Manual 14-D

Generator Operational Requirements

Revision 50

Vince Stefanowicz
Sr. Lead Engineer, Generation
System Operations Subcommittee
September, 5 2019

M-14D – Changes Specific to ESR Participation Model - Metering

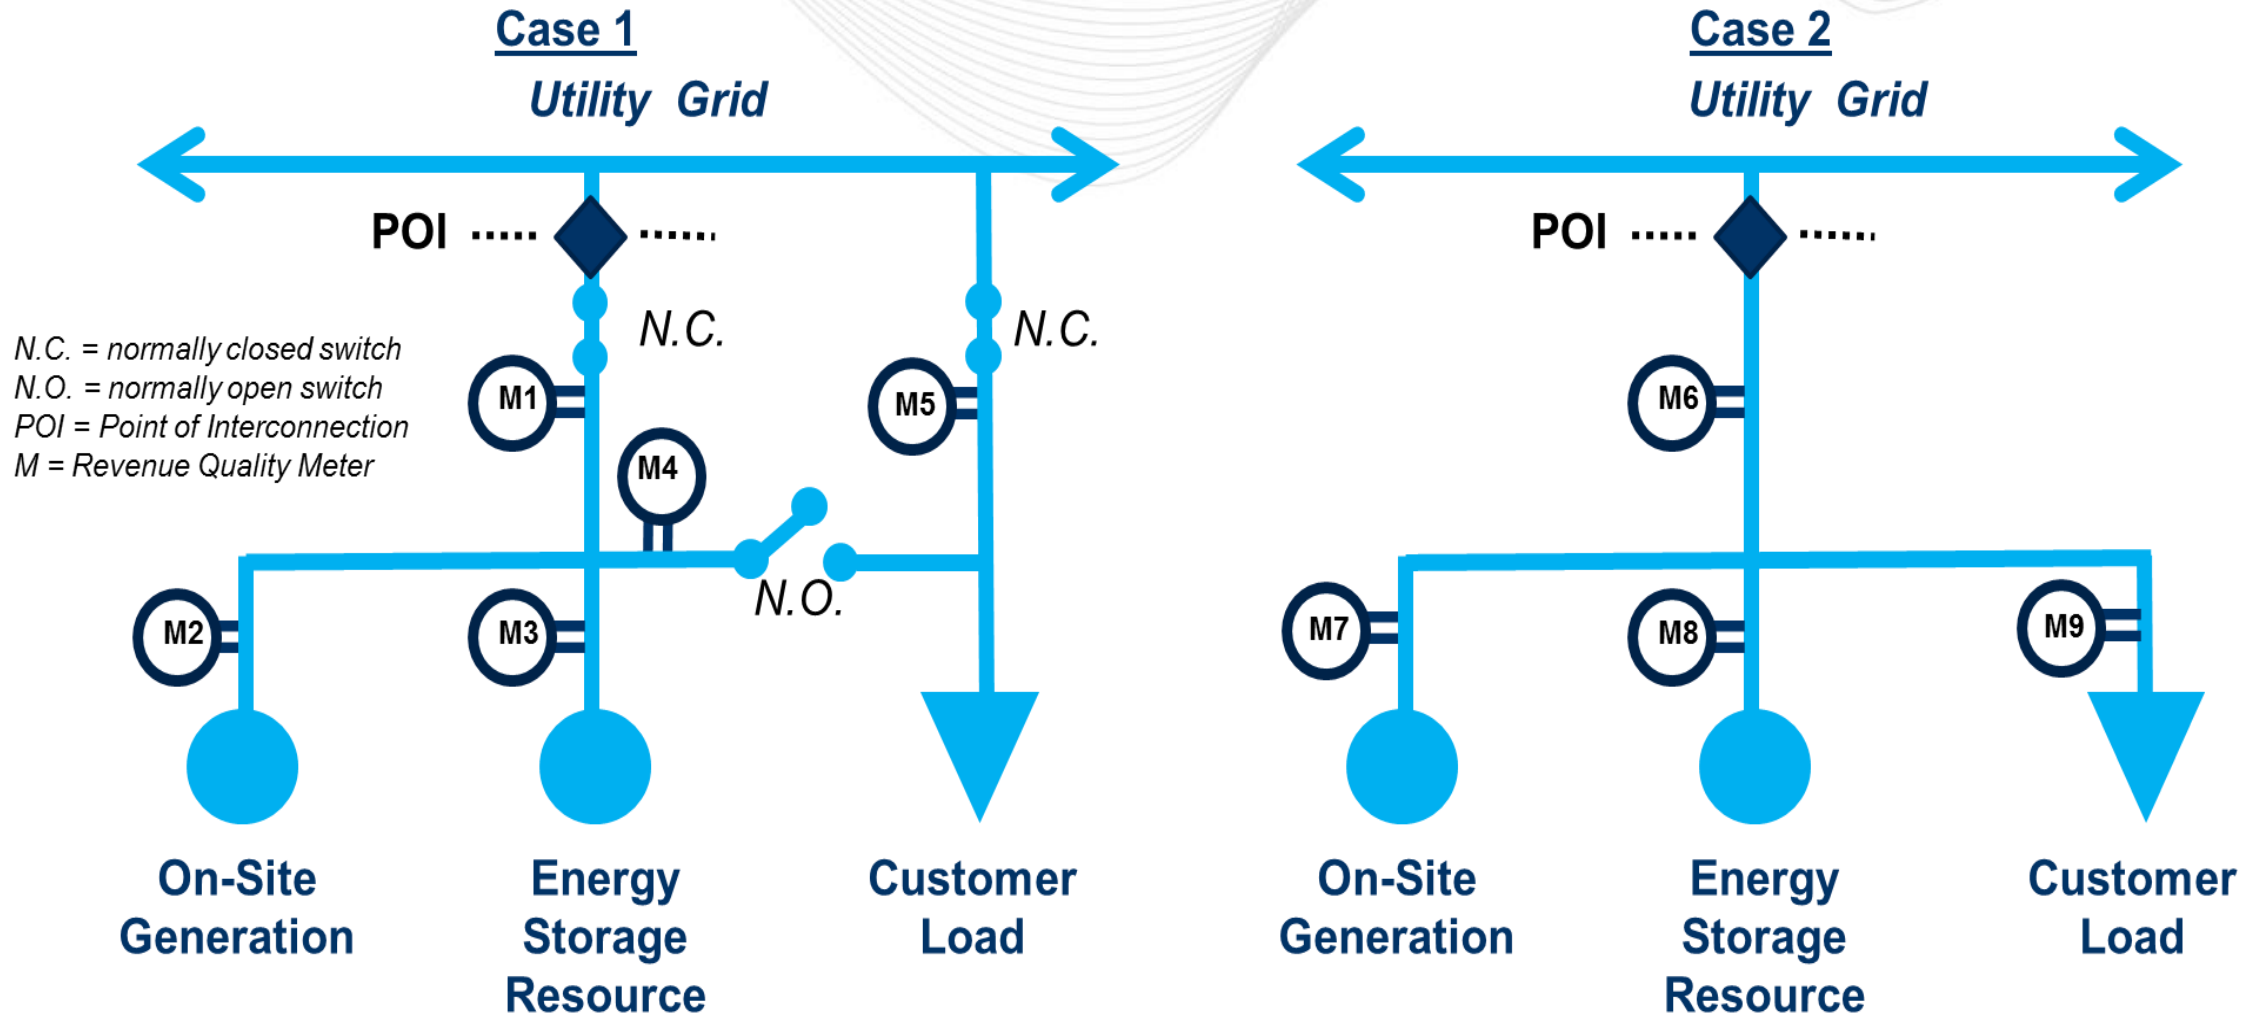
Number and location of measurement devices required will vary depending on how ESR operates

Energy Storage Resources that are co-located with end use load that is not Station Power shall provide a device for measurement of MWh located directly on the Energy Storage Resource terminals (M3 in diagram at left.)

Attachment D: PJM Generating Unit Reactive Capability Curve Specification and Reporting Procedures

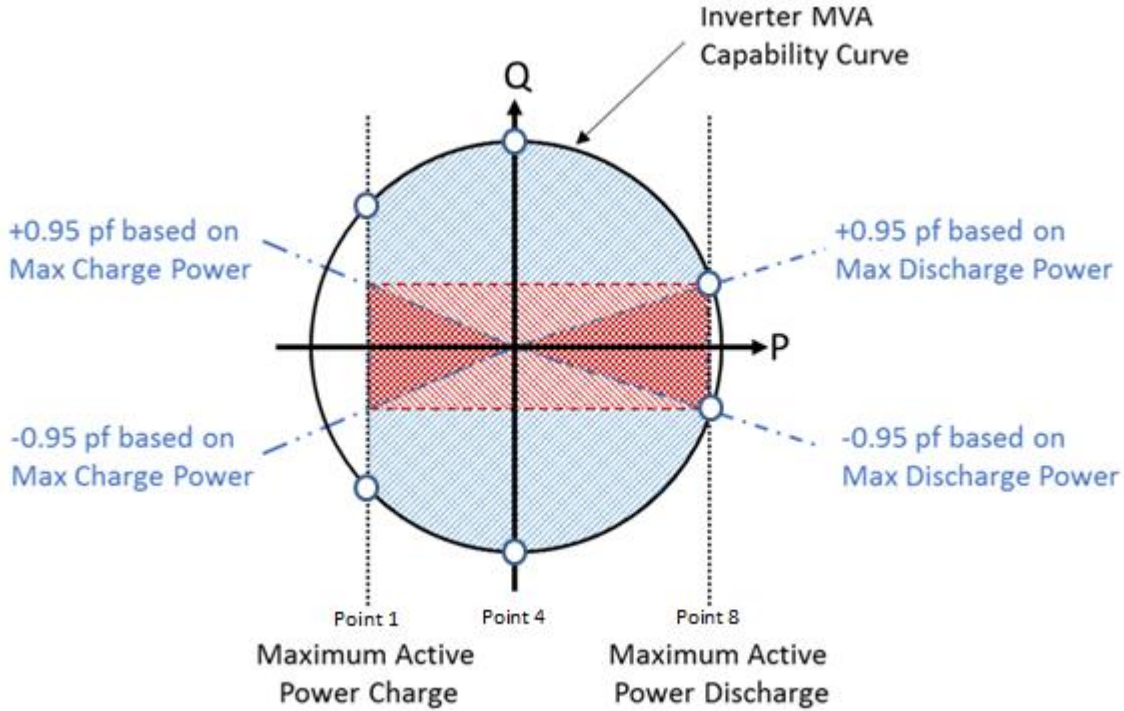
- Updated to include Energy Storage Resources
- Updated stand-alone document containing “D-curve” examples
- See example on next slide

For inverter-based Energy Storage Resources, the reactive capability should be based on Inverter MVA Capability Curve.

Consistent with NERC Guideline on Reactive Capability for Inverter-based Energy Storage Resources
